WELL API NO. <b>30-025-42377</b>
5. Indicate Type of Lease STATE <input checked="" type="checkbox"/> FEE <input type="checkbox"/>
6. State Oil & Gas Lease No.
7. Lease Name or Unit Agreement Name <b>Iggles State Com</b>
8. Well Number <b>#1H</b>
9. OGRID Number <b>229137</b>
10. Pool name or Wildcat <b>Vacuum, Bone Spring, West</b>

<p><b>SUNDRY NOTICES AND REPORTS ON WELLS</b> (DO NOT USE THIS FORM FOR PROPOSALS TO DRILL OR TO DEEPEN OR PLUG BACK TO A DIFFERENT RESERVOIR. USE "APPLICATION FOR PERMIT" (FORM C-101) FOR SUCH PROPOSALS.)</p>	
1. Type of Well: Oil Well <input checked="" type="checkbox"/> Gas Well <input type="checkbox"/> Other <input type="checkbox"/>	
2. Name of Operator <b>COG Operating, LLC</b>	
3. Address of Operator <b>2208 W. Main Street Artesia, NM 88210</b>	
4. Well Location Unit Letter <b>M</b> : <b>330</b> feet from the <b>S</b> line and <b>350</b> feet from the <b>W</b> line Section <b>21</b> Township <b>18S</b> Range <b>34E</b> NMPM County <b>Lea</b>	
11. Elevation (Show whether DR, RKB, RT, GR, etc.) <b>4040' GR</b>

**CONDITIONS OF APPROVAL  
FOR PLUGGING AND ABANDONMENT  
OCD - Southern District**

CURRENT WELL SKETCH

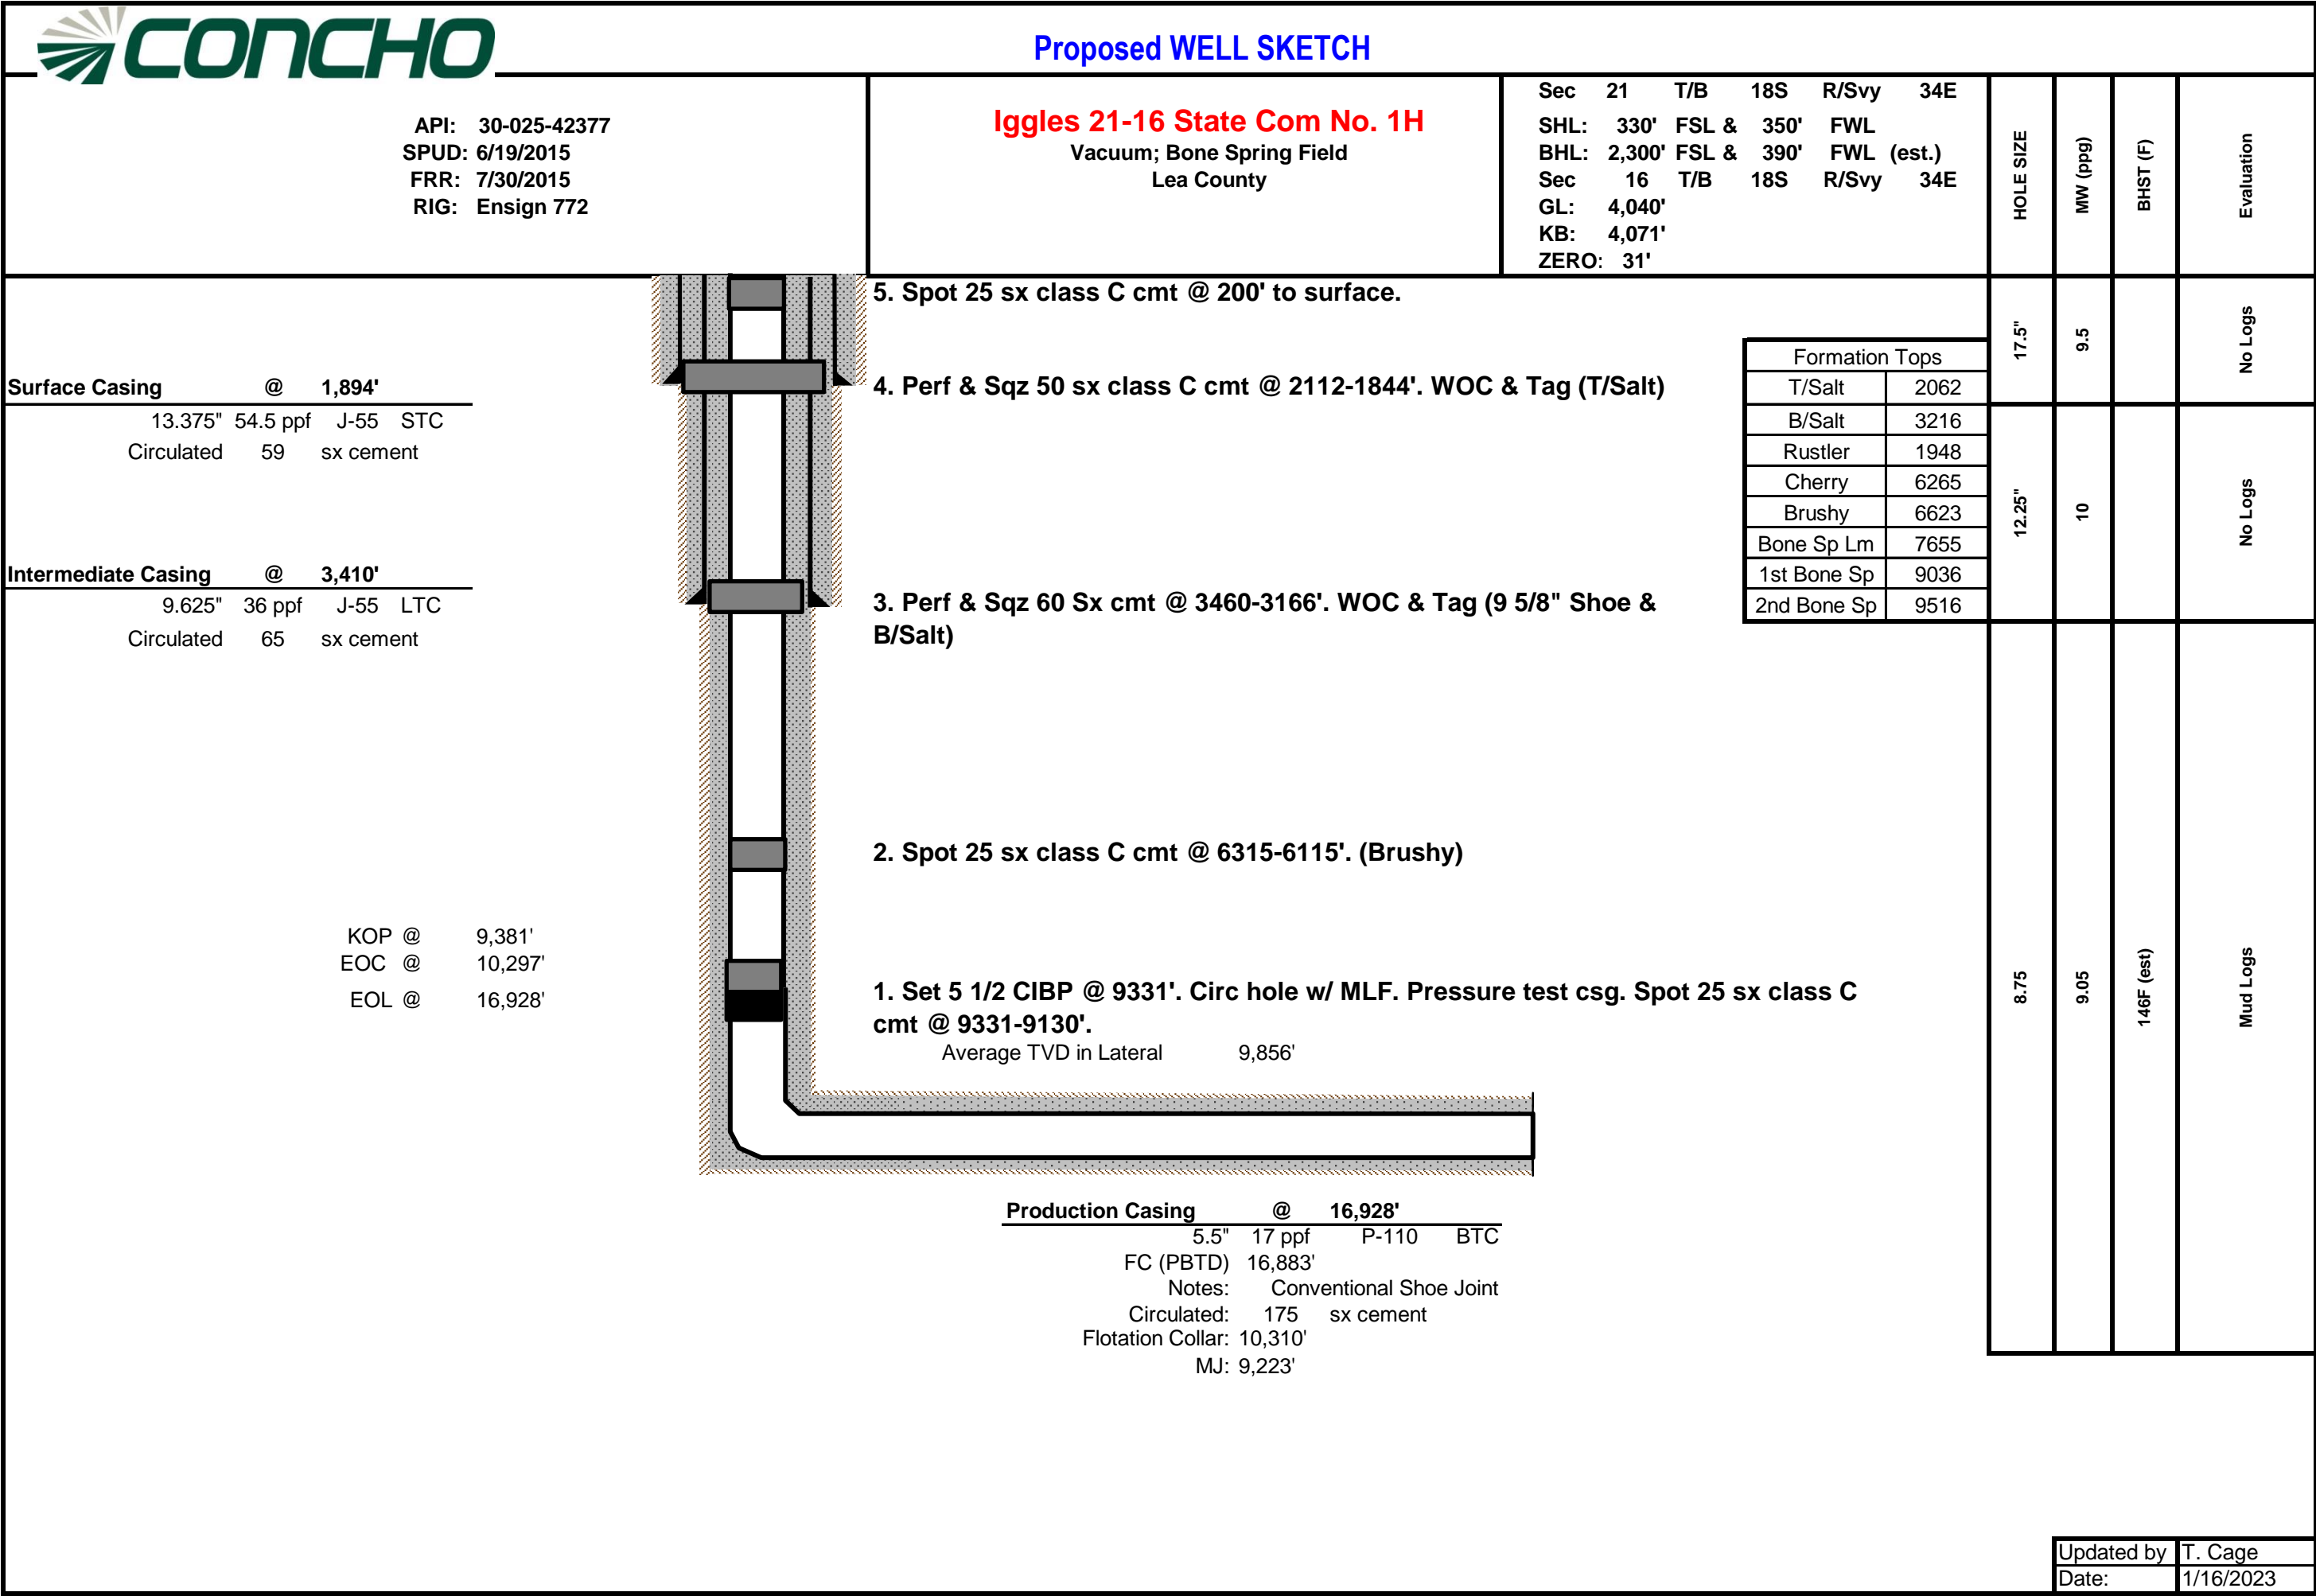
**LPC Area Below ground marker send pics before backfilling hole**
